Monterey Bay Aquarium Research Institute

Title		Document Number		Rev	
Thruster Wiring Fab, LRAUV Int Press Vess Wiring, Build5		100221161		C	
Size	Date:	Engineer	Sheet	of	
B	Thursday, November 05, 2020	Mellingner	2	15	
Design File					
VIDESIGNDRAWINGS\EE_DRAWINGS\LRAUV\WIRING\SYSTEMWIRING\100221189_LRAUV_BUILD5_SYSTEMWIRINGDRAWINGSET.DSN					
Schematic Name		Page Name	Layout File		
LRAUV5BuildInternalWiring		02 Thruster Wiring Fab	<Layout File>

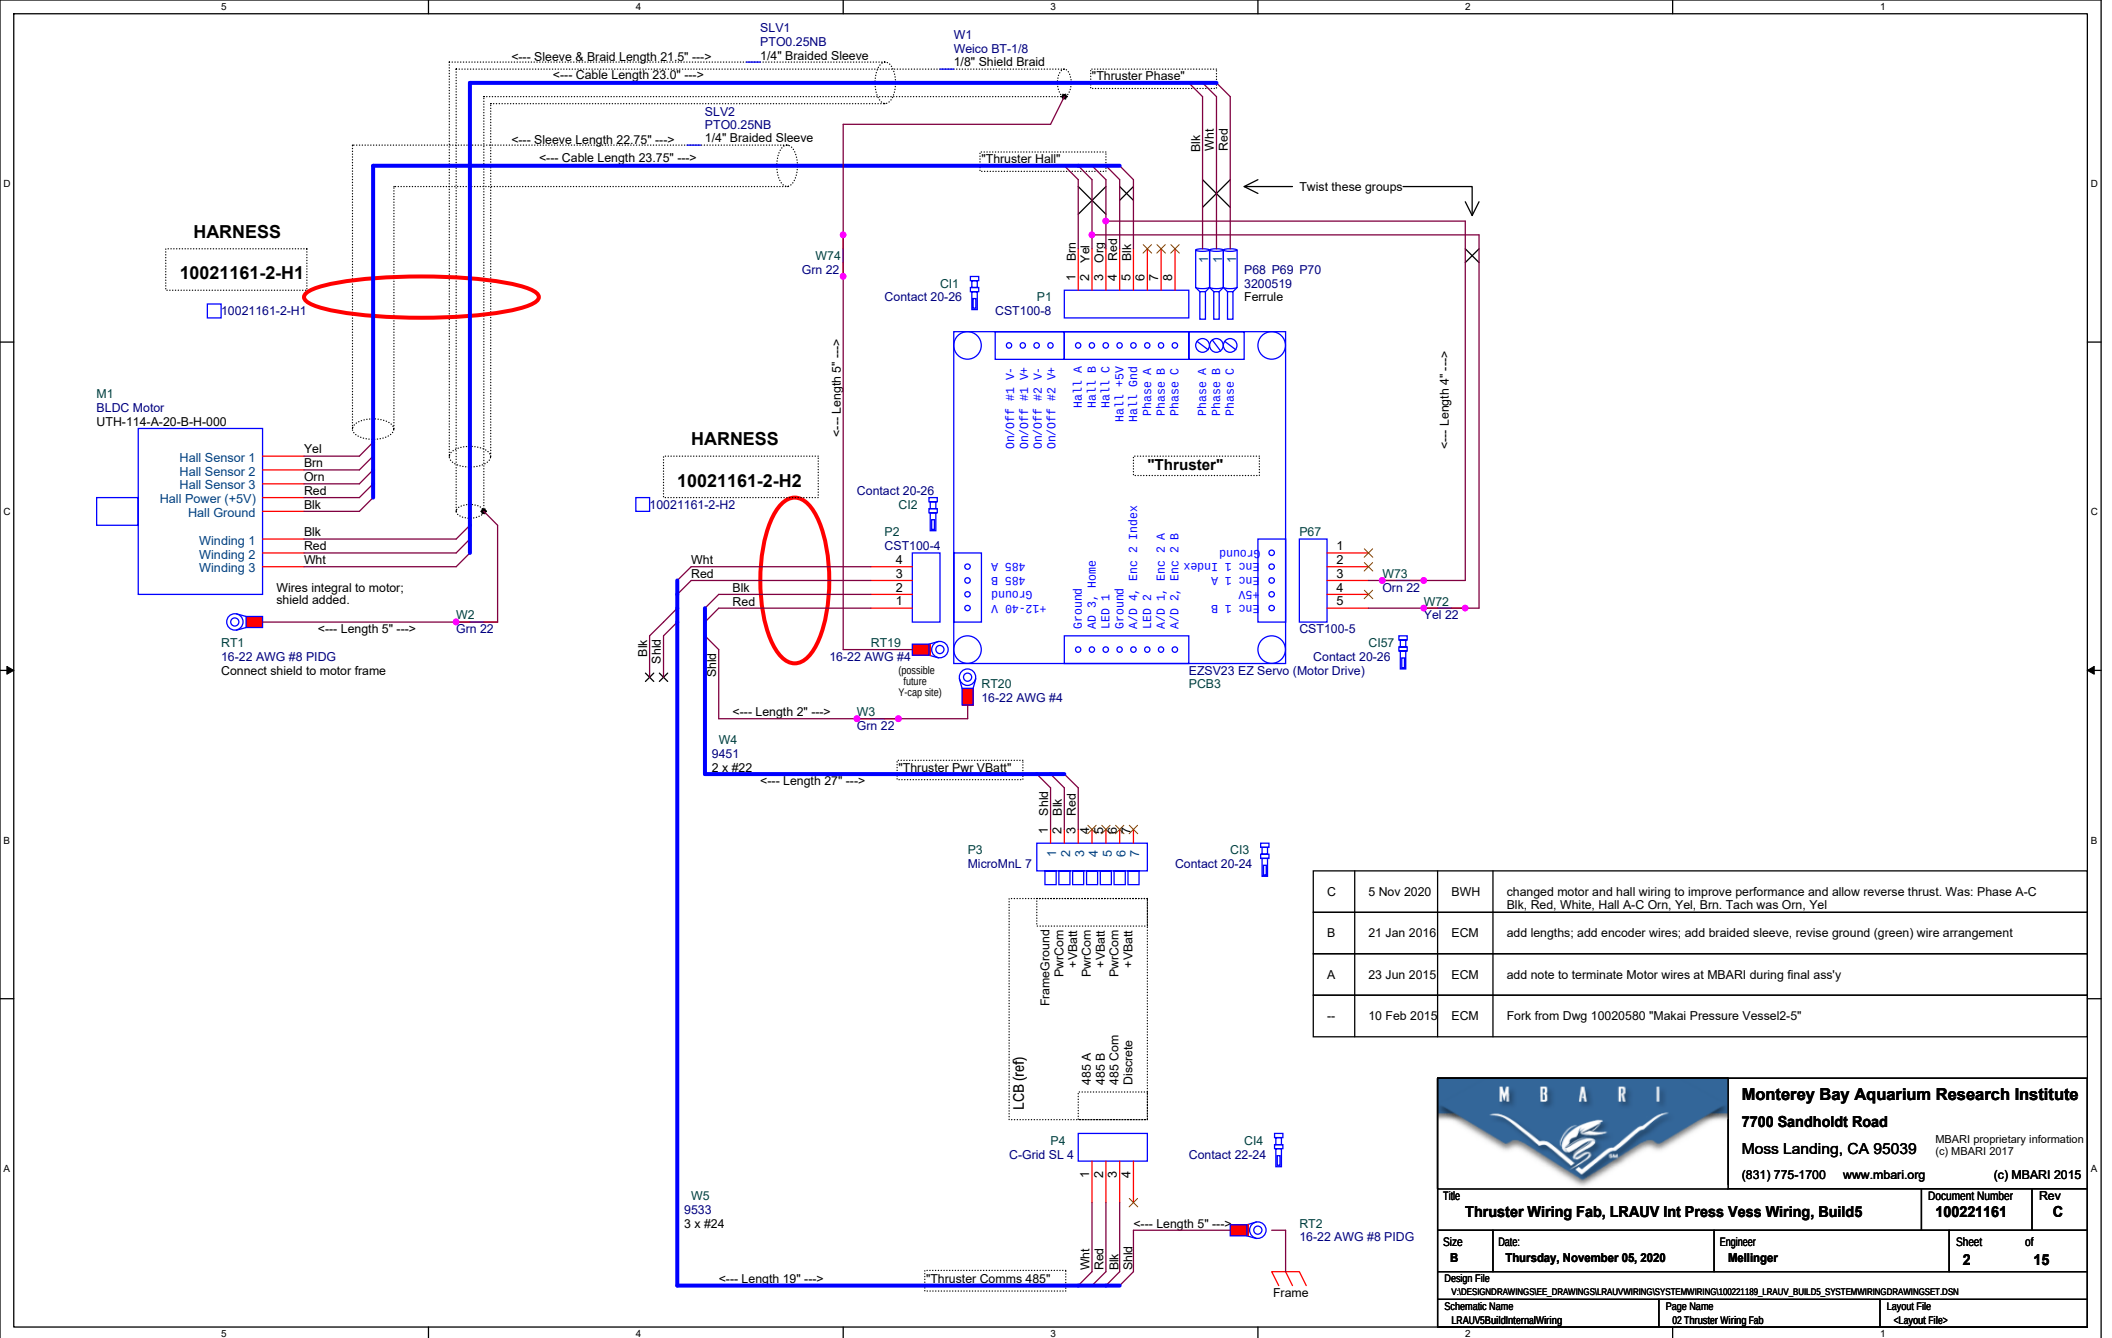
C	5 Nov 2020	BWH	changed motor and hall wiring to improve performance and allow reverse thrust. Was: Phase A-C Blk, Red, White, Hall A-C Orn, Yel, Brn. Tach was Orn, Yel
B	21 Jan 2016	ECM	add lengths; add encoder wires; add braided sleeve, revise ground (green) wire arrangement
A	23 Jun 2015	ECM	add note to terminate Motor wires at MBARI during final ass'y
--	10 Feb 2015	ECM	Fork from Dwg 10020580 "Makai Pressure Vessel2-5"
